SI B 24 50 99
Automatic Transmissions

This Service Information bulletin supersedes S.I. 24 50 99, dated **December 1999**.

Installing the Transmission Cooler Line Clip

E53 X5 SAV

080102

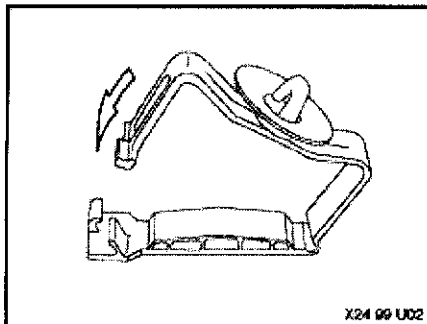
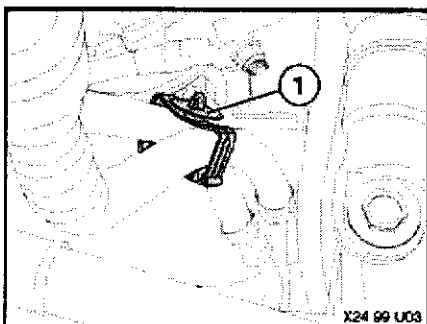
1. Remove the lower front splash pan (black plastic).

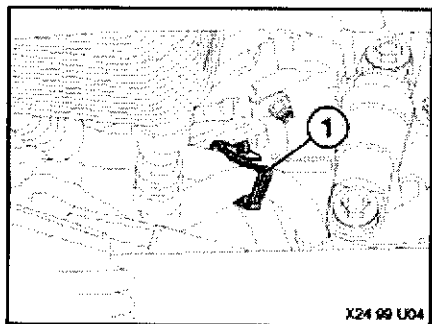
3. Remove the original clip securing the transmission lines(if equipped).
4. Install the revised clip (1), p/n 17 22 1 719 407, onto the transmission lines. The clip must be installed in the center of the hoses as illustrated. **Note:** The original clip may not be attached to all affected vehicles. If the clip is not attached, install the revised clip as described.

5. When the clip is completely installed, make sure the transmission lines have clearance around the A/C compressor, engine block, and other body components.
 - o The "barb" on the new clip (1) does not get attached.

2. Install the revised clip, P/N 17 22 1 719 407, onto the flexible transmission lines as described below:
